Fuels Regulatory Streamlining Amendments

Response to Comments

Assessment and Standards Division
Office of Transportation and Air Quality
U.S. Environmental Protection Agency

Figure 1. Example of Wrapper Batch Movement into Breakout Tankage

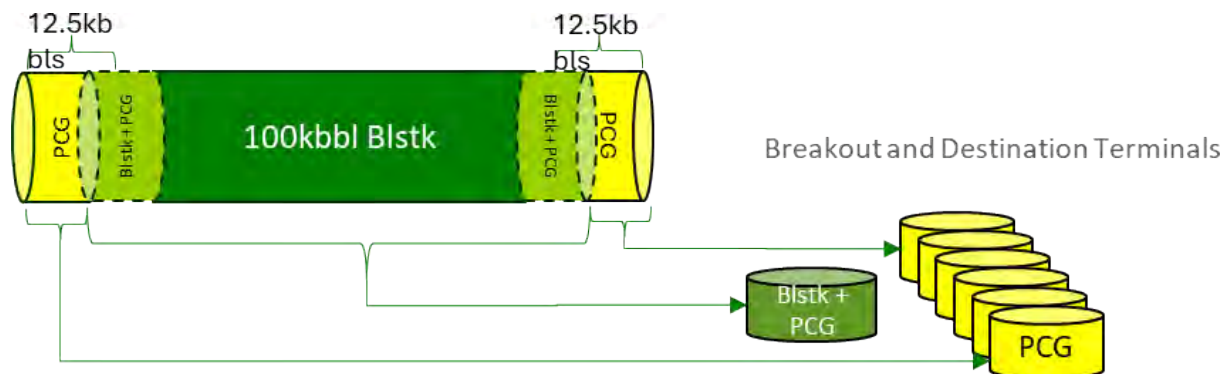
bp recommends that EPA provide manufacturers with an alternative method to characterize the commingled PCG/blendstock portion of the wrapper batches. Specifically, bp proposes that EPA allow fuel manufacturers to mathematically determine the sulfur and benzene characteristics of the blended PCG wrapper batches based on the change in the blendstock's properties between its point of origin and its ultimate destination. Such a calculation merely requires sampling the blendstock prior to shipment as well as at the end of the pipeline, which is operationally feasible to do. With an understanding of the properties of the blendstock before and after shipment, it is possible to ascertain mathematically the characteristics of the PCG and use those characteristics in compliance reporting for compliance-by-subtraction under Section 1090.1320.

For example: A batch of blendstock illustrated in Figure 1 is tested at the point of origin with sulfur and benzene values of 7 ppm and 0.46 volume percent, respectively. Such blendstock might be shipped for downstream blending because it does not meet other commercial gasoline specifications due to low octane, higher RVP, or other parameters. The PCG wrappers described in Figure 1 would then be included before and after the blendstock as it is shipped on a fungible pipeline. At its intended destination, the resulting mixture of blendstock and PCG is sampled for sulfur and benzene values of 9 ppm and 0.48 volume percent. The volume of PCG mixed into the blendstock in the course of its shipment can be determined because the overall volume of the blendstock has increased by 10,000 barrels.

A simple equation can calculate the sulfur and benzene characteristics of the 10,000 barrels of added PCG: $(\text{Value of Sulfur or Benzene at Destination} \times \text{Volume at Destination} - \text{Value at Origin} \times \text{Volume at Origin}) / (\text{Volume at Destination} - \text{Volume at Origin})$. Applying the equation to this hypothetical, the sulfur and benzene of the added PCG would be 29 ppm and 0.68 volume percent.

The regulations currently include a provision for the scenario of being unable to measure a PCG parameter by allowing for compliance using either the presumed value for the PCG volume or an EPA-approved alternative value as described in 40 CFR 1090.1710(g). The commenter's discussion of wrapper batches fits well within the existing provisions to allow for compliance based on an EPA-approved alternative value under 40 CFR 1090.1710(g). We are therefore not making further changes to the regulation at this time in response to this comment.
